**Monitoring Report
Year 4
FINAL**

Little Buffalo Creek Stream Mitigation Project

*NCDEQ-DMS Project Number: 94147
Contract Number: 2029
USACE Permit Action ID: 2014-00386
DWR Permit: 14-0129
Cabarrus County*

Subject: DRAFT Monitoring Year 4 report for the
Little Buffalo Creek Stream Mitigation Project
Yadkin River Basin – CU# 03040105– Cabarrus County
DMS Project ID No. 94147
Contract # 002029

NCDEQ Division of Mitigation Services	
Little Buffalo Creek Stream Restoration, Cabarrus County, NC DMS Project # 94147	
Project Location Map	
 THE LOUIS BERGER GROUP 1001 Wade Avenue, Suite 400 Raleigh, NC 27605	Figure 1 November 2016

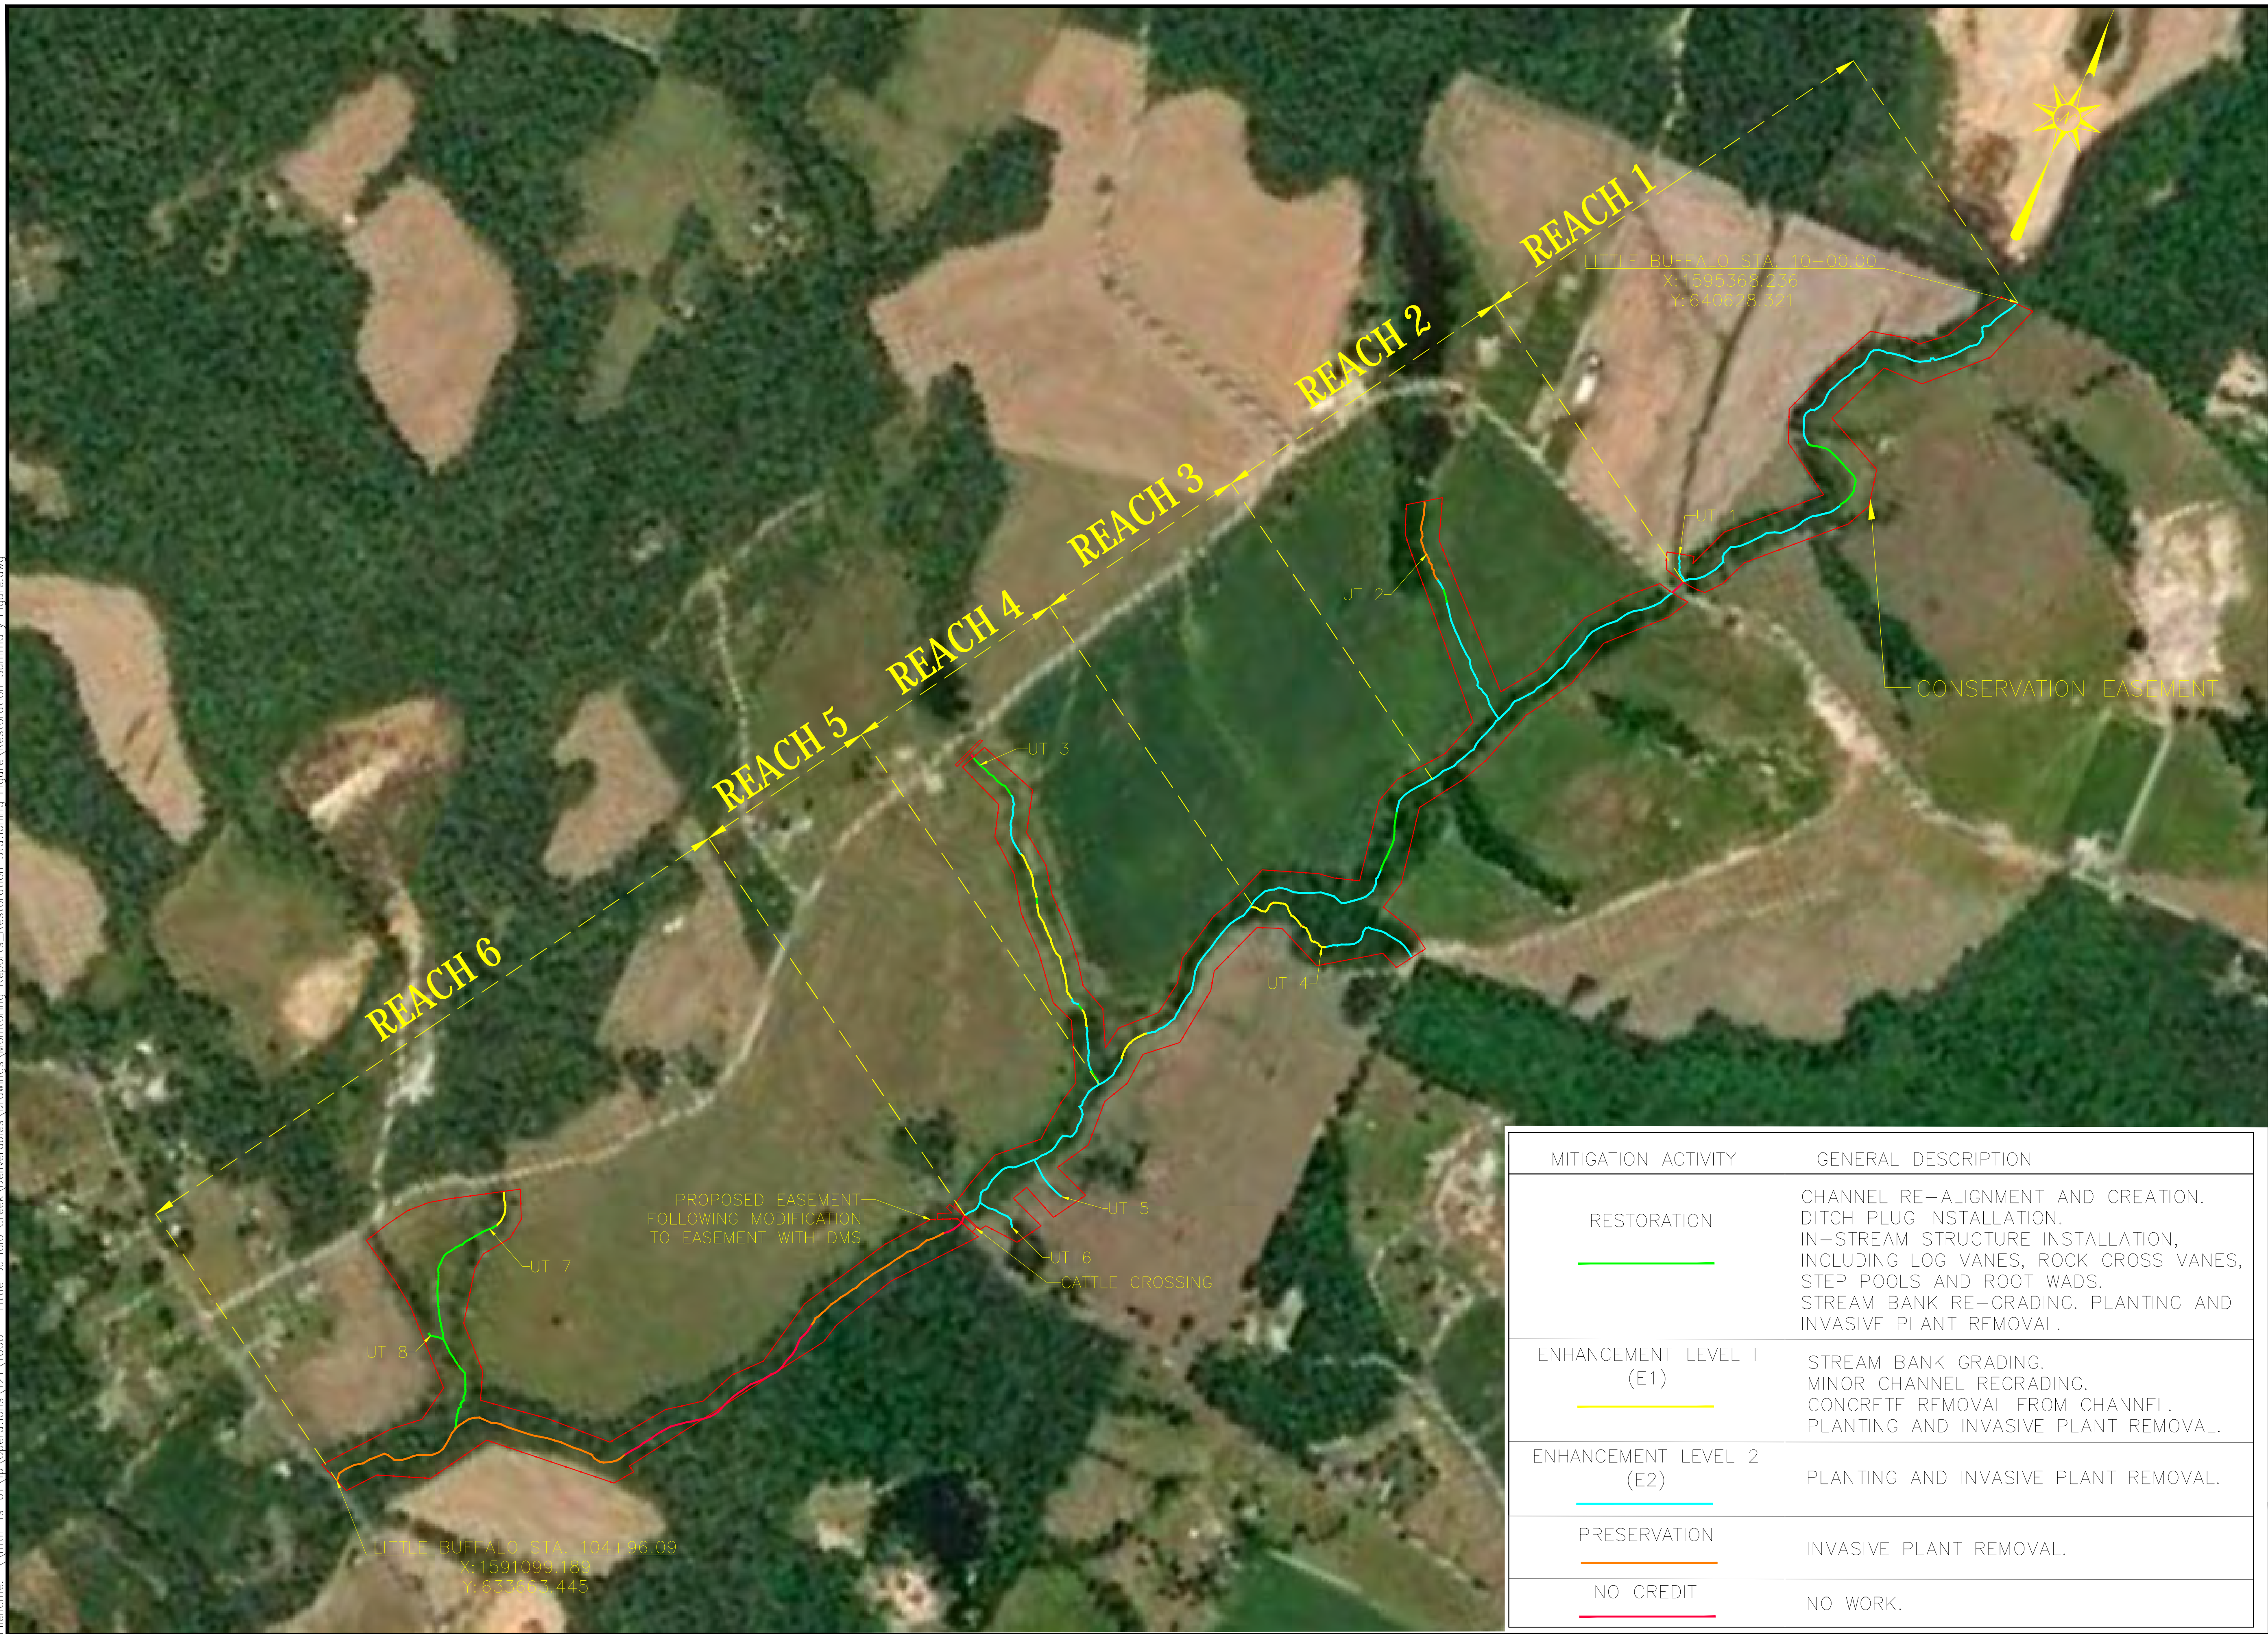
CCPV Figures – The magenta hatch for encroachment/cow prints should be removed from the reach figures. The information would be less obstructive and better summarized in Figure 1 using the hatch or leaders with text. Please review the CCPV figures and Tables 5a-g for completeness regarding aggradation in UT 2 and UT 3. Please consider changing the light blue text color for the call outs as it is difficult to see in the figures.

- **CCPV Figures –** The magenta hatch for encroachment/cow prints should be removed from the reach figures. The information would be less obstructive and better summarized in Figure 1 using the hatch or leaders with text. Please review the CCPV figures and Tables 5a-g for completeness regarding aggradation in UT 2 and UT 3. Please consider changing the light blue text color for the call outs as it is difficult to see in the figures.

- *The magenta hatch for encroachment has been removed and leaders added. Text color for the callouts has been changed to a darker color. UT2 and UT3 have been revised for aggradation along the areas of linear wetlands. As no additional aggradation in MY4 was observed in the portion of UT3 impacted by the MY2 encroachment incident, this area is not shown for aggradation on the CCPV for MY4 or within Table 5a-g. This information has been updated in Tables 5a-g also. UT2 in Table 5a-g in past has been focused on the*
